Consistent Depiction of Connectors

Associated with Comment 406 (and 396)

Comment #406

CI 176D SC 176D.7.1 P 821 L 27 # 406

Figure 176D-6—Reference insertion loss budget at 53.125 GHz

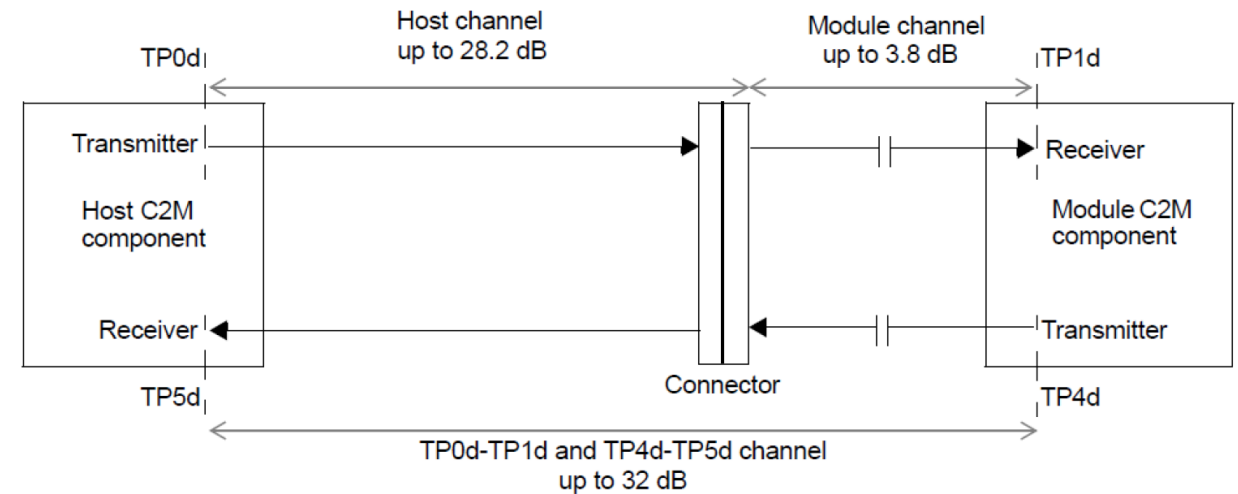
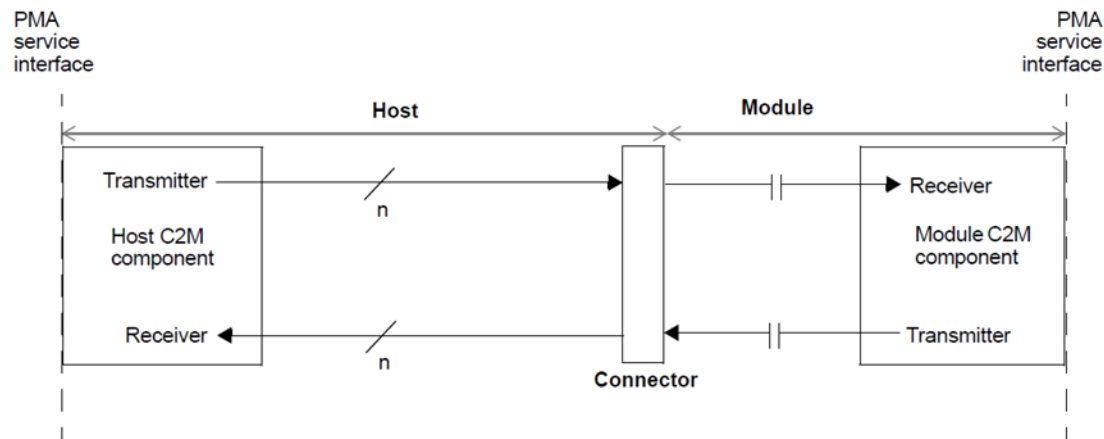
The depiction of the connector in Figure 176D-6 is inconsistent with the connector shown in other figures in the document (e.g., Figures 120C-2, 135E-2, 135G-2, . The end point of the Host channel loss is ambiguous.

Changing the symbol for the connector creates confusion

- The figure looks wrong and raises questions
 - Where is the other half of the connector?
 - Where does the 28.2dB host allocation end?
- If the idea is to omit any part of the module connector in the host loss budget, then show the host loss terminating at the end of the host part of the connector
- If we ***really*** do not want to show two parts of the connector, then explain in the text why this is shown differently from all preceding depictions of connectors

Change Figure 176D-6 to that shown to the right. Change the note under the figure to read: "NOTE—For loss budgeting purposes, the Host channel loss is from TP0d to the center of the edge connector of the module.

Figure 120G-3—Host compliance points

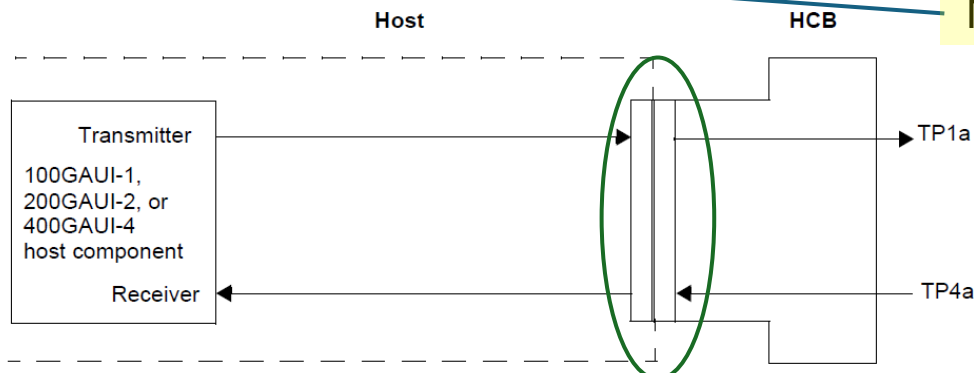
Note typo!

Figure 179–2—200GBASE-CR1, 400GBASE-CR2, 800GBASE-CR4 or 1.6TBASE-CR8 link diagram

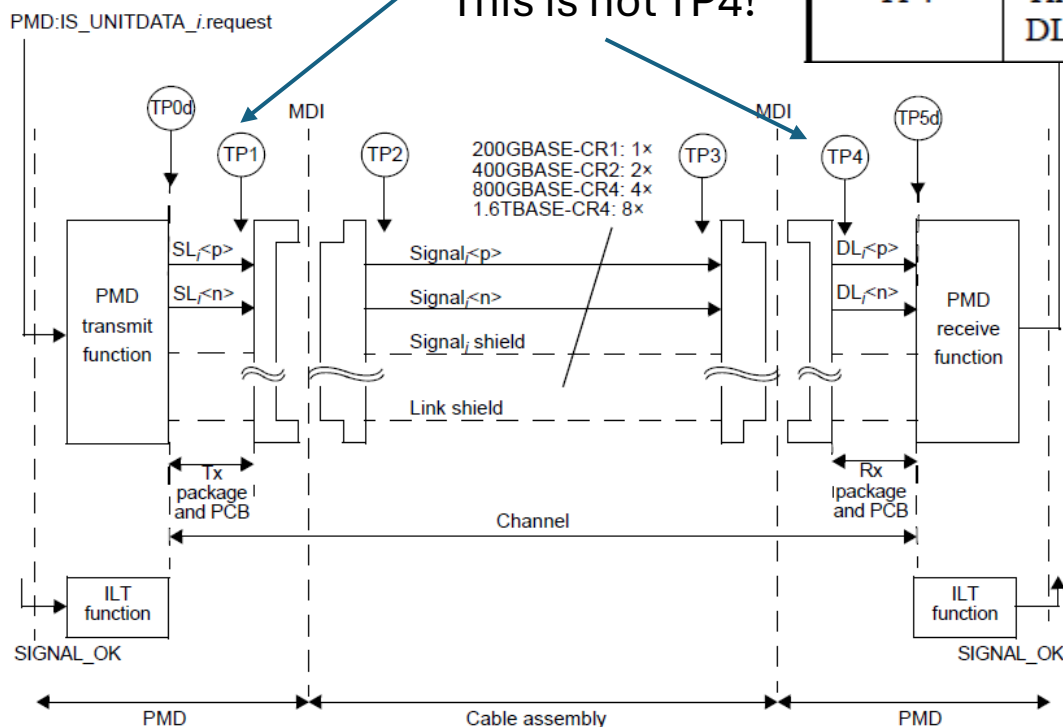
This is not TP1!

This is not TP4!

This is TP1

This is TP4

Figure 179–2—200GBASE-CR1, 400GBASE-CR2, 800GBASE-CR4 or 1.6TBASE-CR8 link diagram

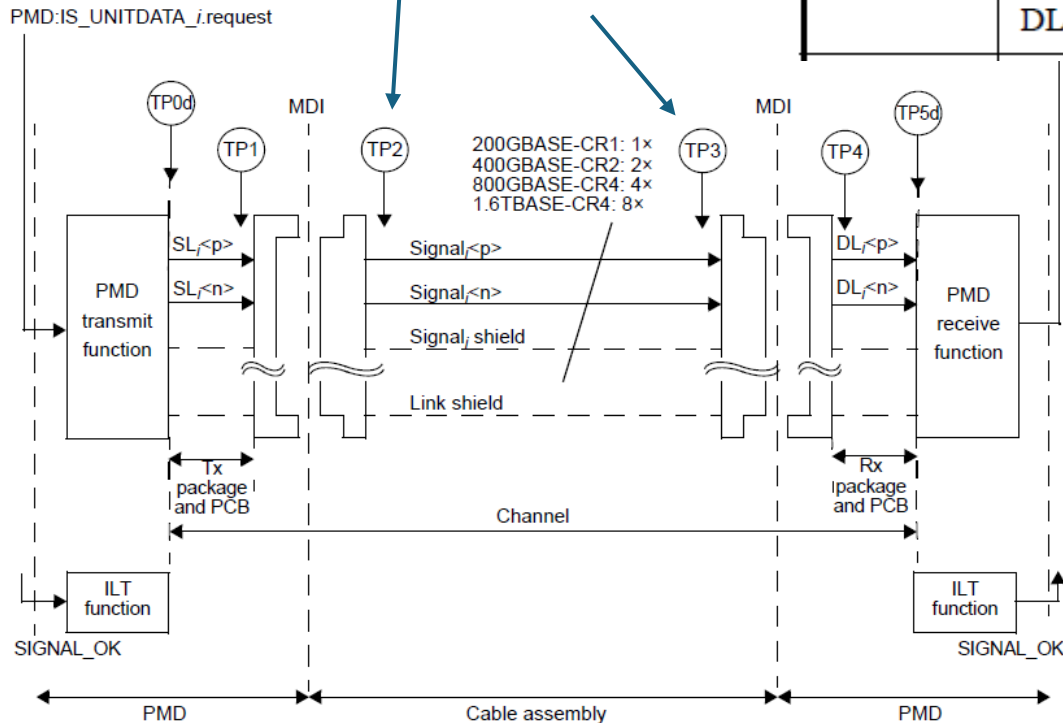
This is not TP2!

This is not TP3!

This is TP2

This is TP3
